## **Addendum # 1 Recreation Center Storage Addition**

Date of Addendum: 5/25/2023

## Revised Drawings – Becker Morgan

**G101**  
COPYRIGHT © 2023

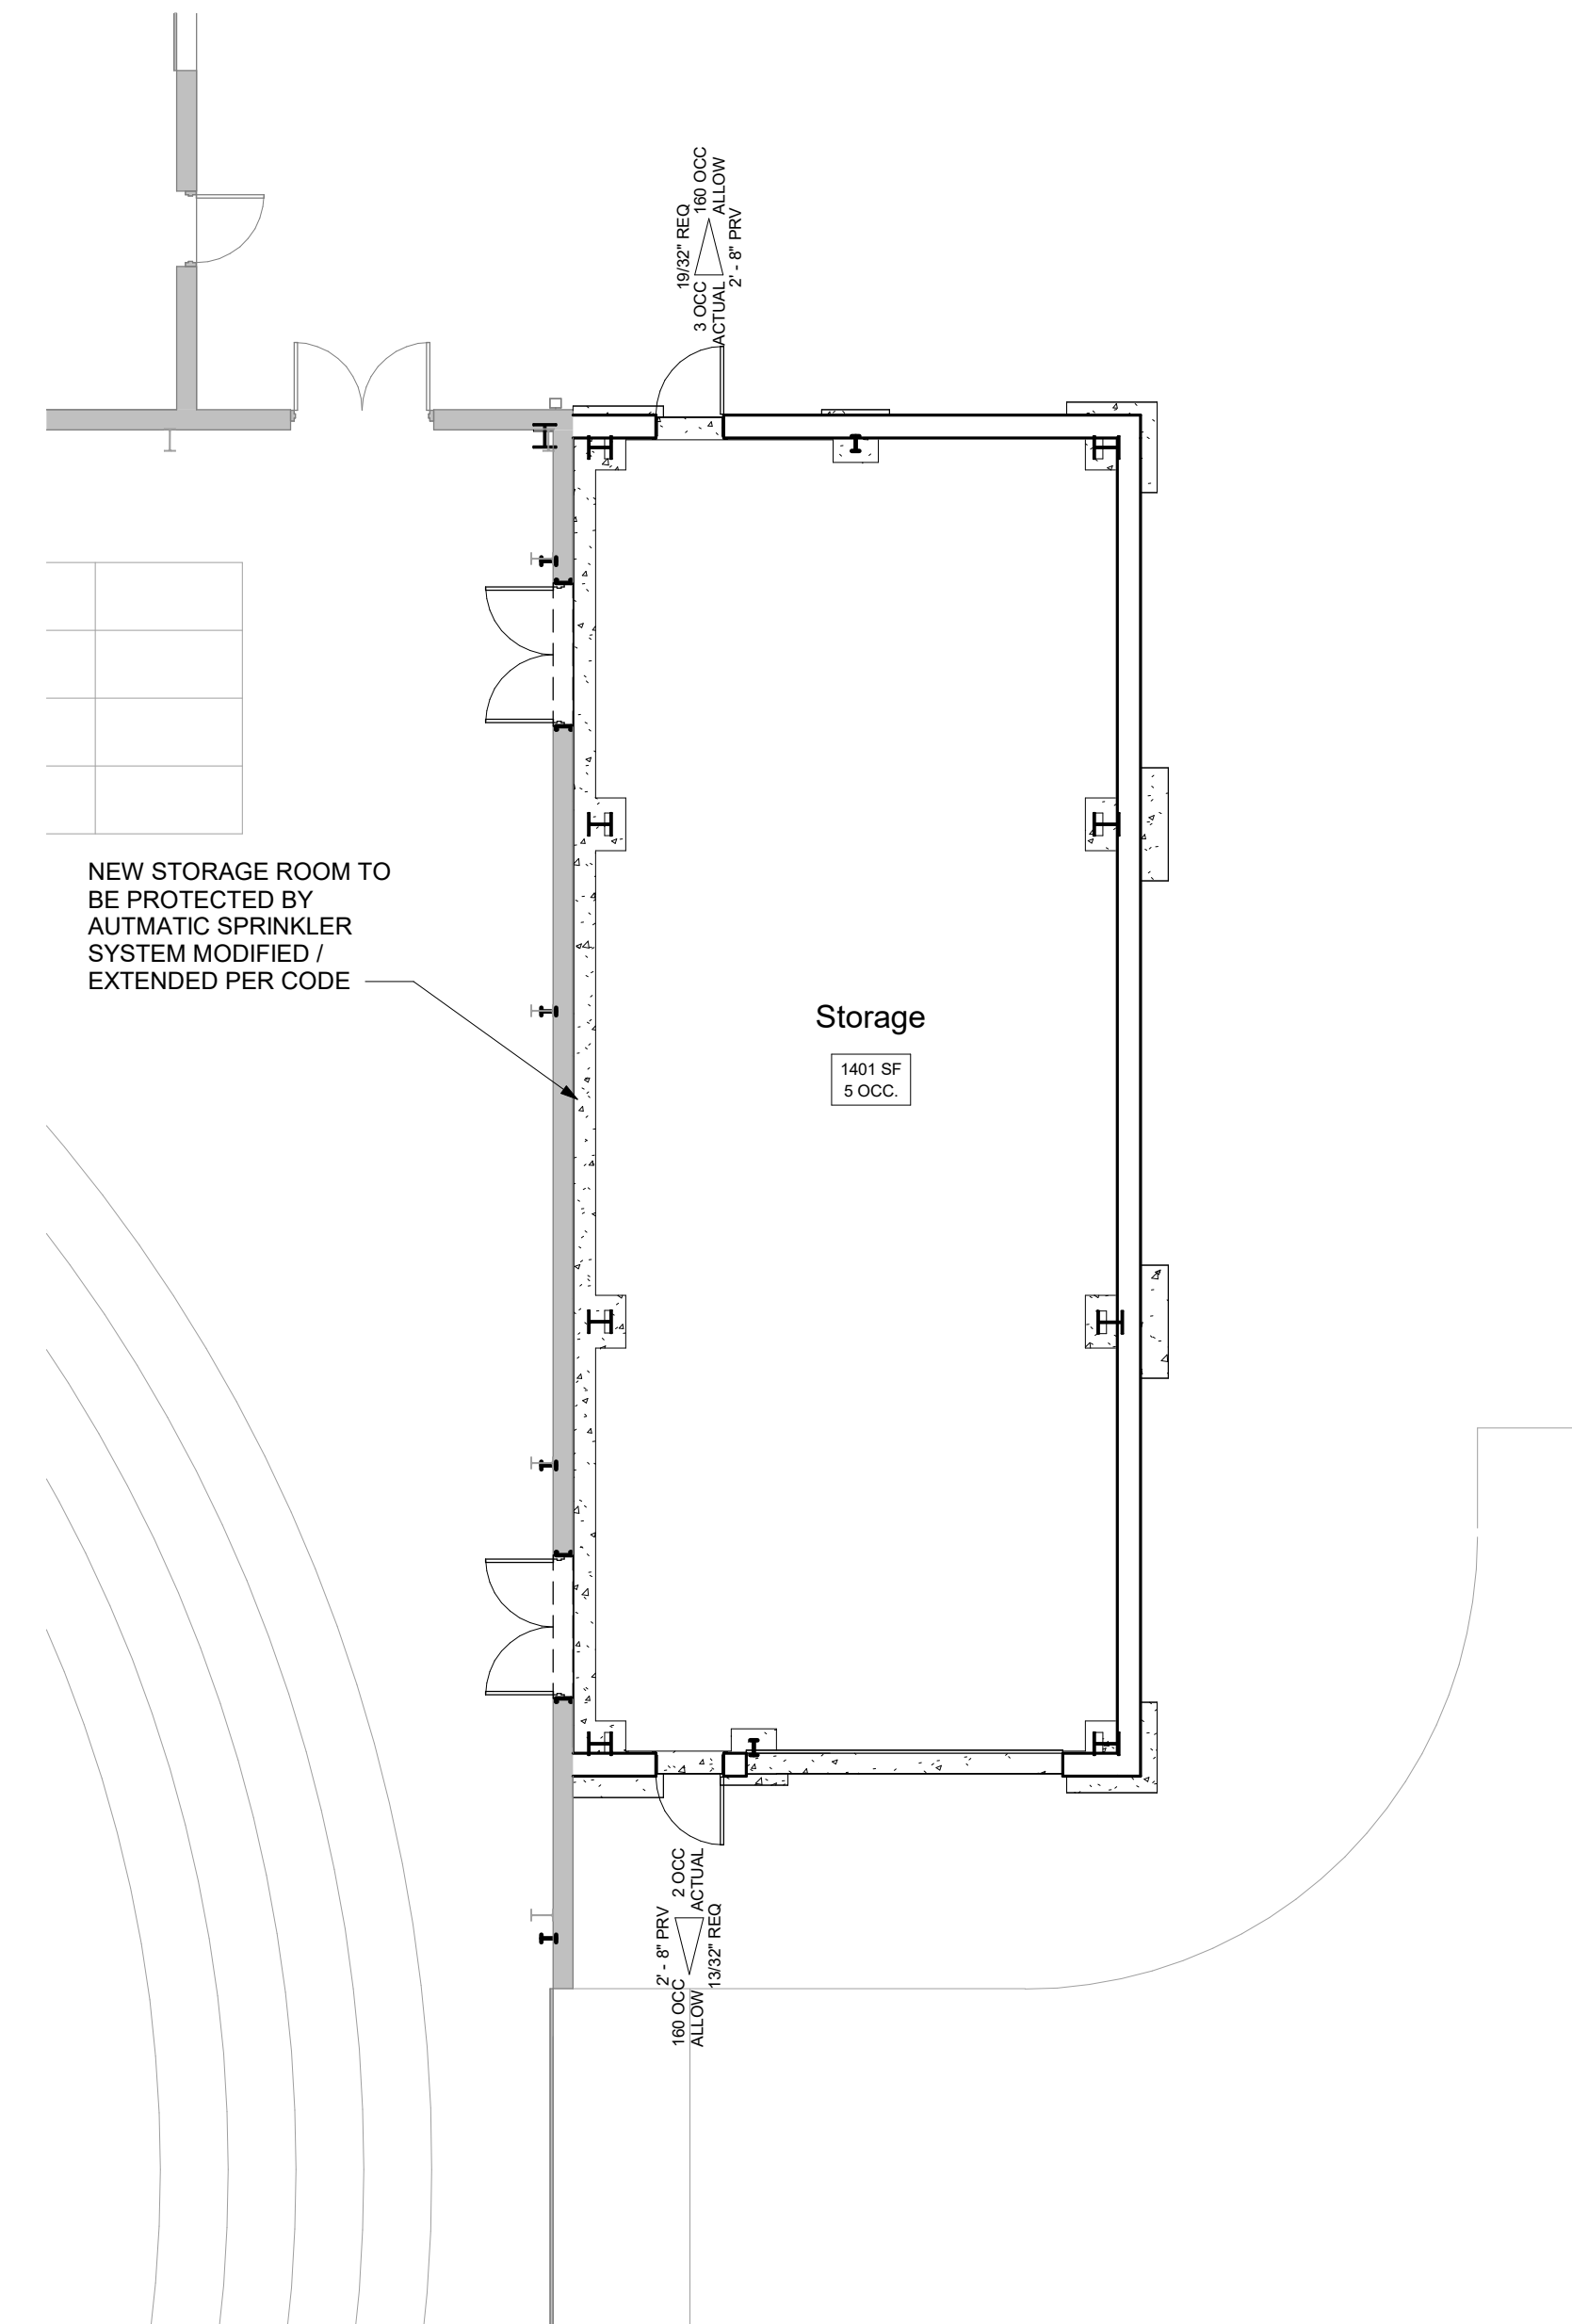
- 1) Drawing Sheet G001 – General Mechanical, Electrical, & Plumbing Notes: Note added - “2f. Egress lighting and exit signs as required by code.”
- 2) Drawing Sheet G101 – Construction Type corrected from Type III-B to Type II-B non-combustible. Type II-B does not require rated building components.

**C-002**

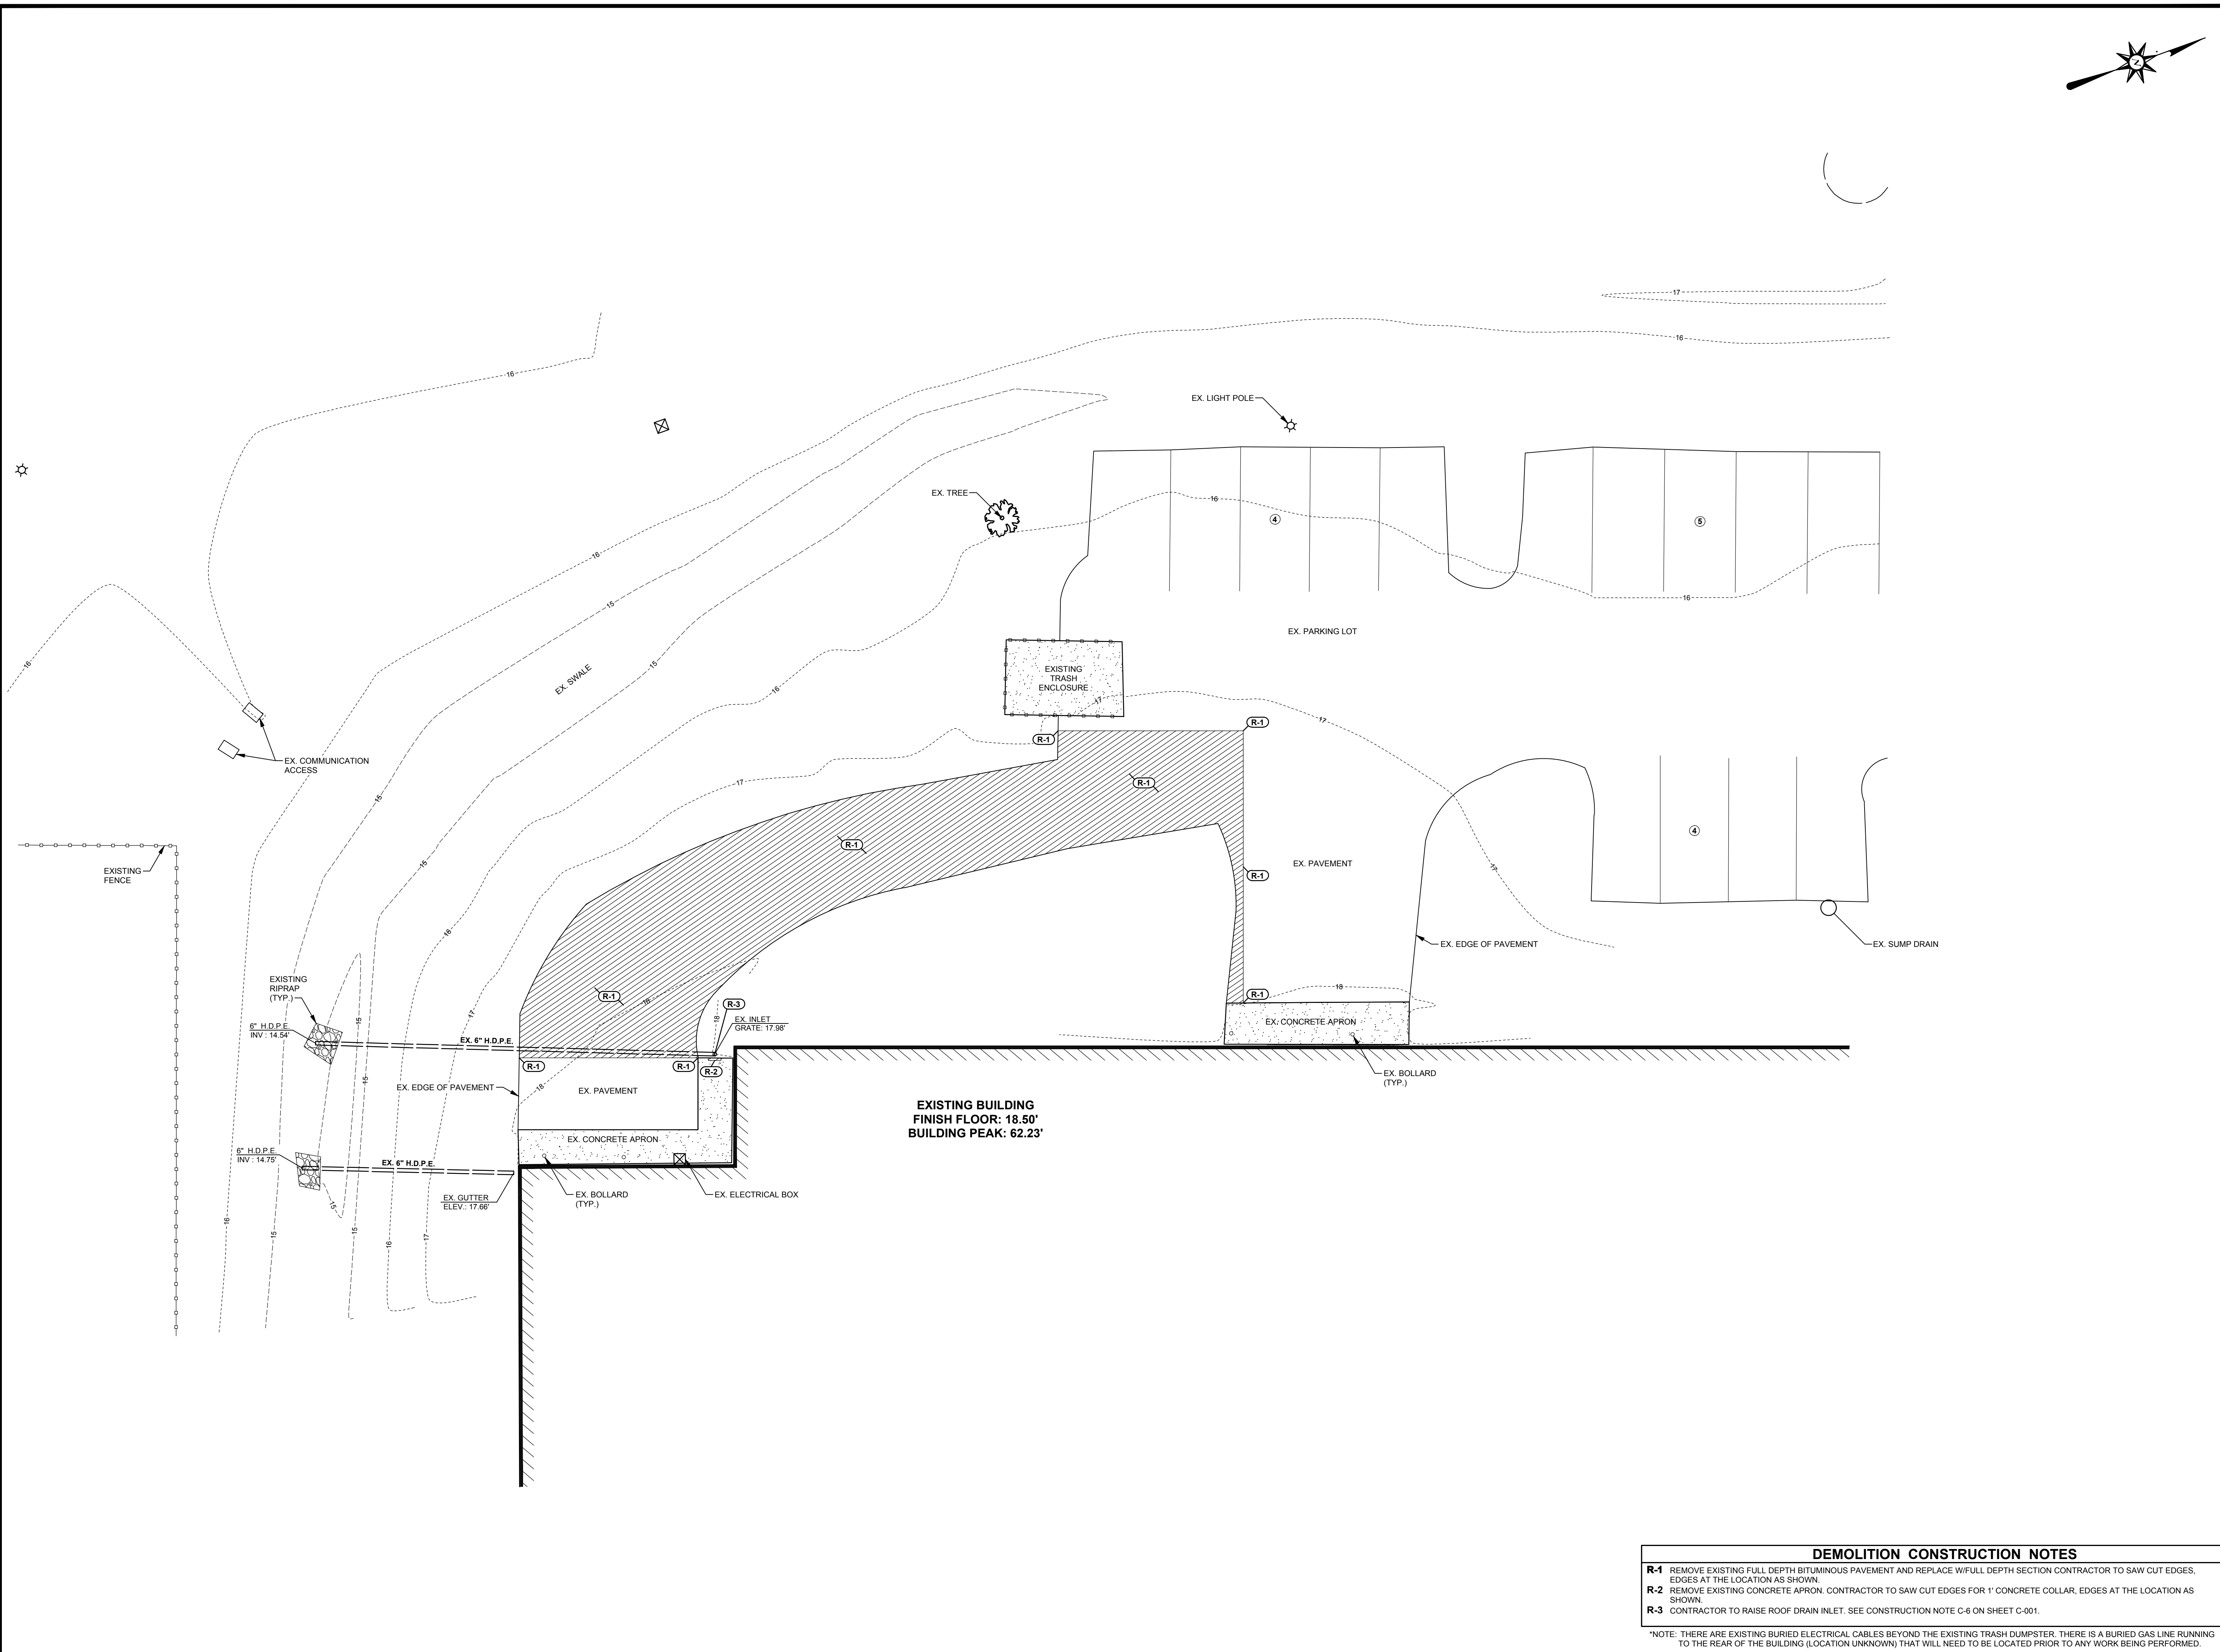
- 3) Drawing Sheet C-001 – Owners Certification – Name changed to current President.
- 4) Drawing Sheet C-002 – Note added below Demolition Construction Notes – “There are existing buried electric cables beyond the existing trash dumpster. There is a buried gas line running to the rear of the building (location unknown) that will need to be located prior to any work being performed.”

\*NOTE: THERE ARE EXISTING BURIED ELECTRICAL CABLES BEYOND THE EXISTING TRASH DUMPSTER. THERE IS A BURIED GAS LINE RUNNING TO THE REAR OF THE BUILDING (LOCATION UNKNOWN) THAT WILL NEED TO BE LOCATED PRIOR TO ANY WORK BEING PERFORMED.

**1A PARTIAL FIRST FLOOR AT STORAGE (ADD/ALT #1)**  
SCALE: 1/8" = 1'-0"

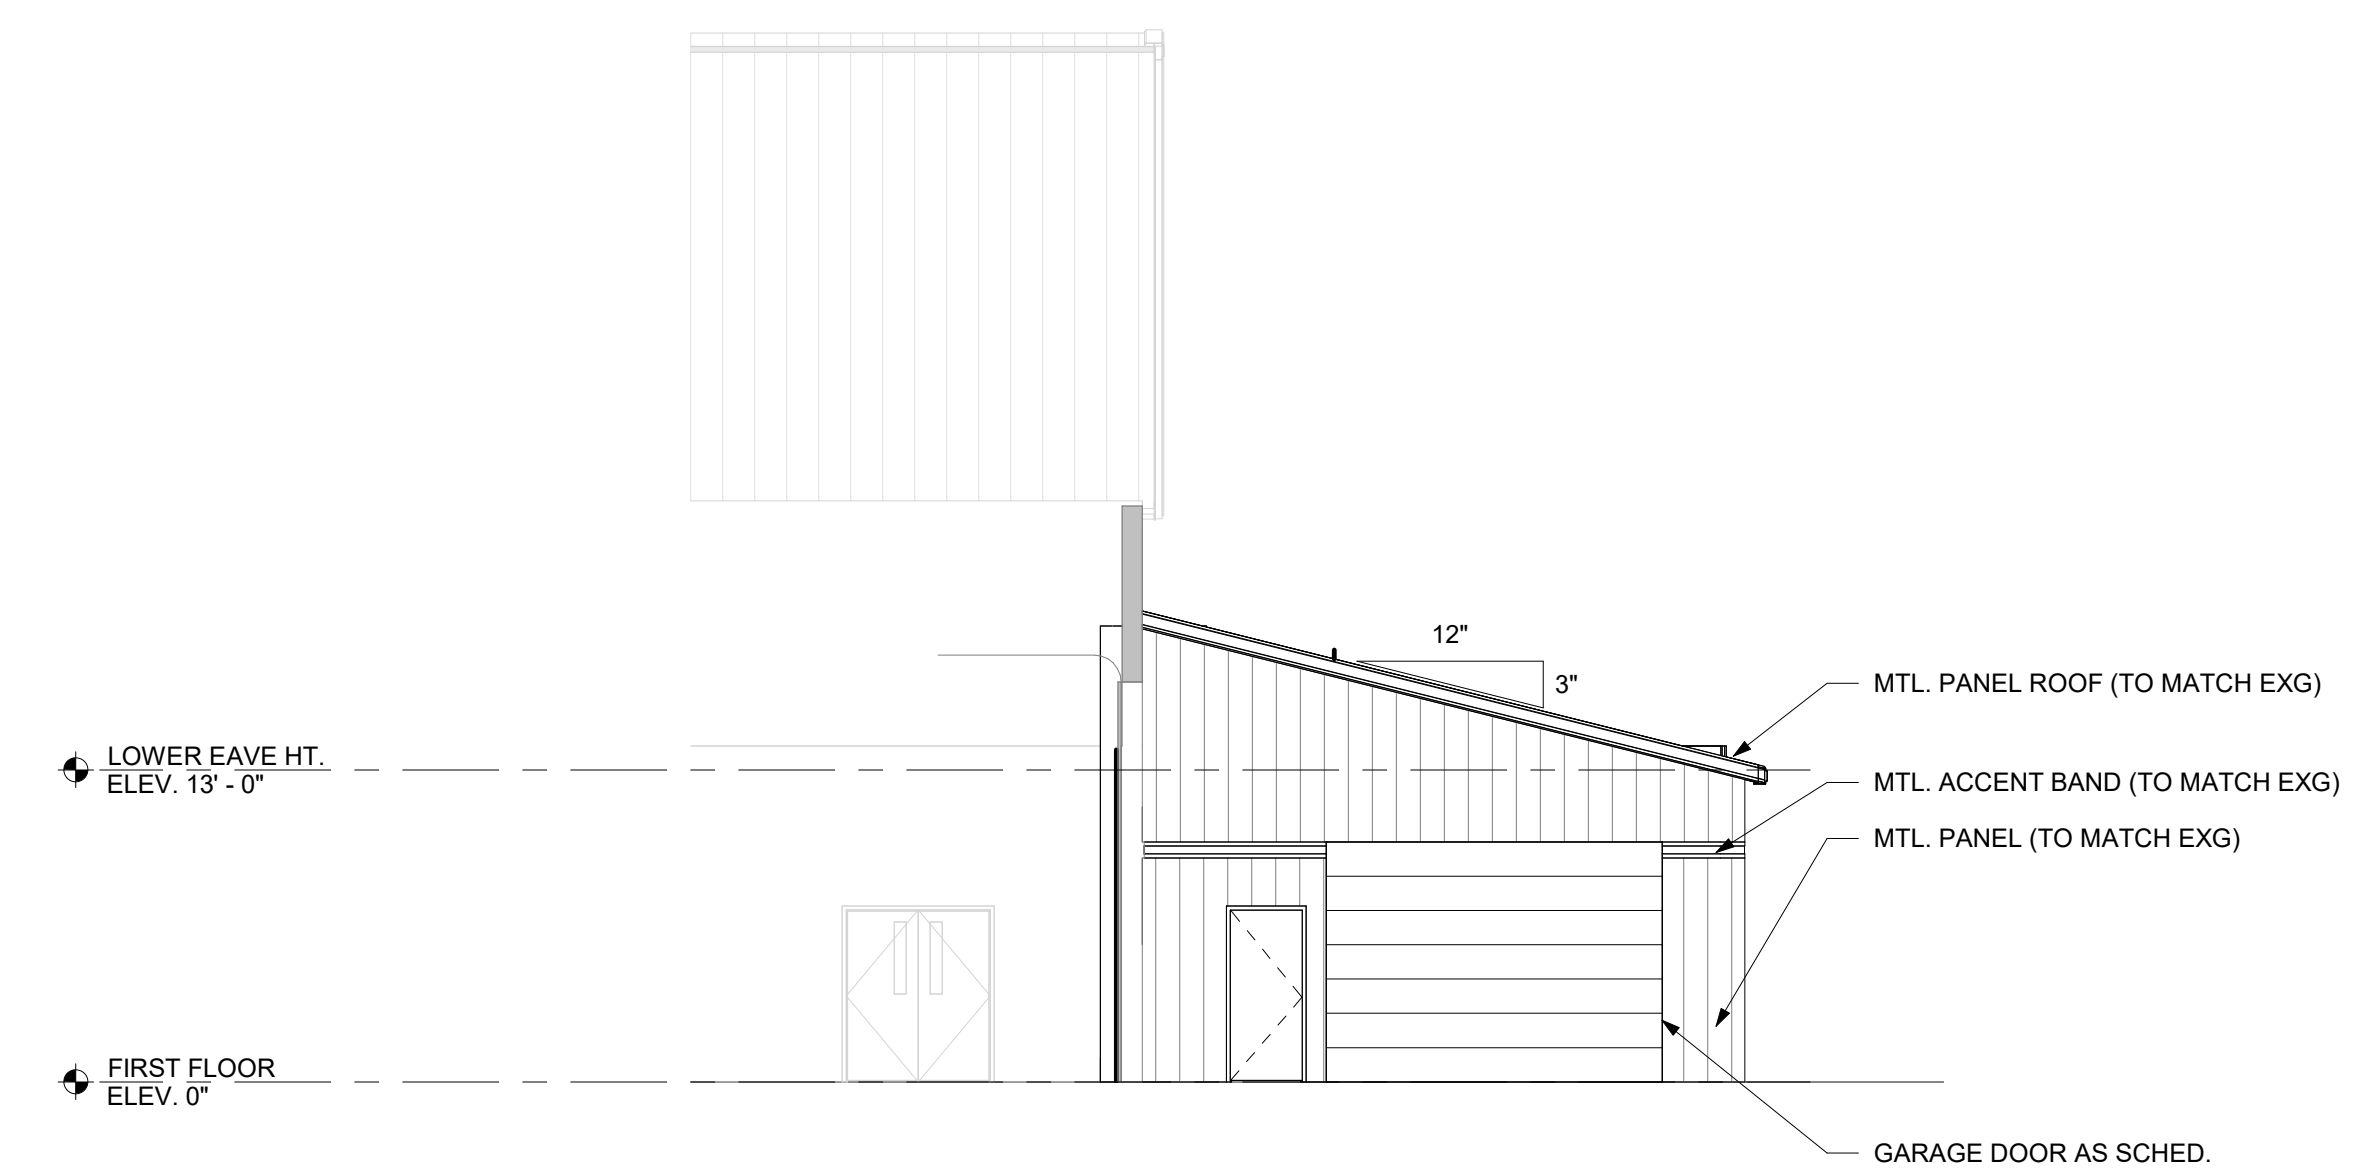
10. The architectural drawings will be updated as an addendum.
11. An add alternate is added for an interior roll-up door supply and install in lieu of a double door – see architectural drawings update.

- 1) Drawing Sheet G001 – General Mechanical, Electrical, & Plumbing Notes – revised as noted
- 2) Drawing Sheet S101 – Notes – Add Alternate Note 2 added.
- 3) Drawing Sheet A101 – Add Alternate Partial Plan 1A added.
- 4) Drawing Sheet A101 – Metal Liner Panel note added to Wall Section 3 for further clarification of Detail 4.
- 5) Drawing Sheet A601 – Door Schedule, Drawings, & Notes updated. Door Hardware Schedule added.
